Official Transcript of Proceedings
NUCLEAR REGULATORY COMMISSION

Title: Advisory Committee on Reactor Safeguards
 Plant License Renewal Subcommittee

Date: Wednesday, September 8, 2010

6 SUBCOMMITTEE ON PLANT LICENSE RENEWAL

Figure 16
EFFECT OF TEMPERATURE ON THE ZIRCONIUM-WATER REACTION

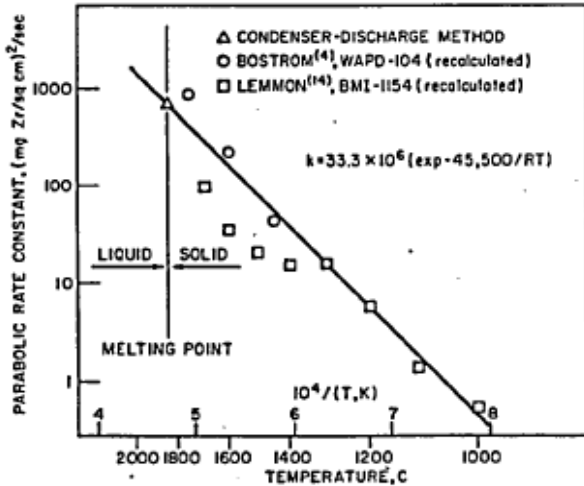
4. Contrary to the exceptionally firm consistency between the NEI and NRC appraisals of Baker-Just, the pertinent data sets published since the Baker-Just correlation was developed have clearly demonstrated the non-conservatism of the Baker-Just correlation above 1800°F. The NRC has not recognized that investigations that involve heating of single specimens of zirconium alloys in steam do not yield applicable data for the temperature or range of temperatures at which thermal runaway is initiated.

5. NRC has apparently never studied Baker-Just (ML050550198) and until April 2010 it did not even have copies of the key references. Figure 16 is copied from page 37 of the Baker-Just report ML050550198.

Only the Lemmon data includes the pertinent temperature region. The Lemmon report, ML100570218, was not acquired by NRC until April, 2010. Thus, NRC never studied Baker-Just. Figure C-1 is from page C-4 and the adjacent figure is excerpted from the flow sheet, Figure C-3 on page C-5.

FIGURE C-1. ZIRCALOY 2 SPECIMEN

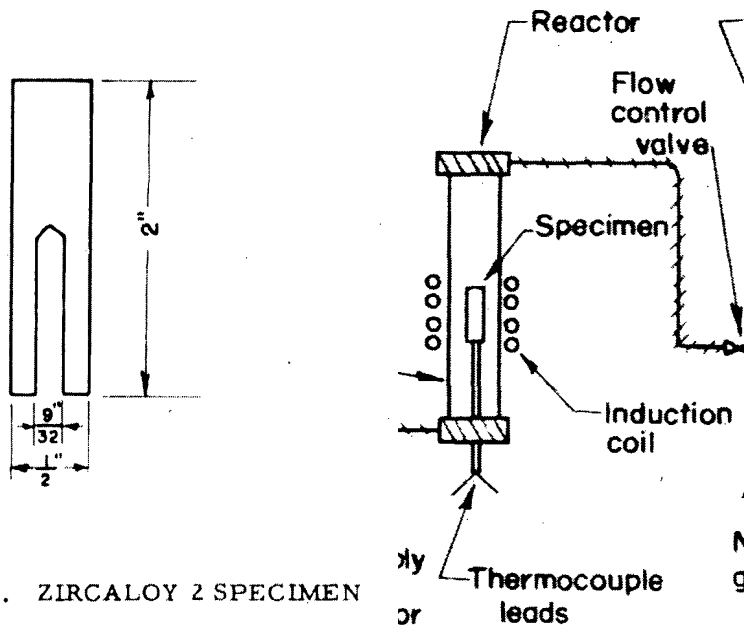
Lemmon induction heated a zircaloy-2 cylinder, 2" long by 0.5" dia. in steam.

Figure 16
EFFECT OF TEMPERATURE ON THE ZIRCONIUM-WATER REACTION

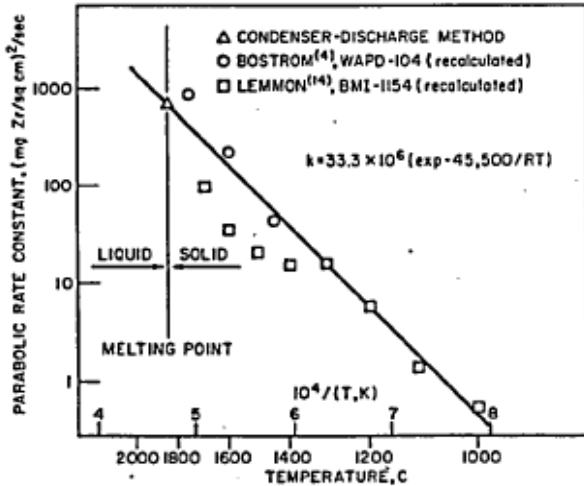
4. Contrary to the exceptionally firm consistency between the NEI and NRC appraisals of Baker-Just, the pertinent data sets published since the Baker-Just correlation was developed have clearly demonstrated the non-conservatism of the Baker-Just correlation above 1800°F. The NRC has not recognized that investigations that involve heating of single specimens of zirconium alloys in steam do not yield applicable data for the temperature or range of temperatures at which thermal runaway is initiated.

5. NRC has apparently never studied Baker-Just (ML050550198) and until April 2010 it did not even have copies of the key references. Figure 16 is copied from page 37 of the Baker-Just report ML050550198.

Only the Lemmon data includes the pertinent temperature region. The Lemmon report, ML100570218, was not acquired by NRC until April, 2010. Thus, NRC never studied Baker-Just. Figure C-1 is from page C-4 and the adjacent figure is excerpted from the flow sheet, Figure C-3 on page C-5.

FIGURE C-1. ZIRCALOY 2 SPECIMEN

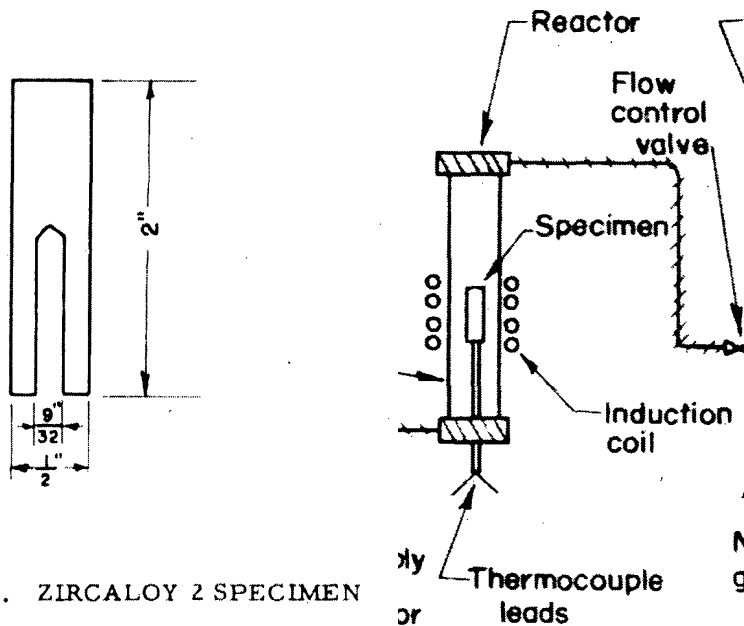
Lemmon induction heated a zircaloy-2 cylinder, 2" long by 0.5" dia. in steam.
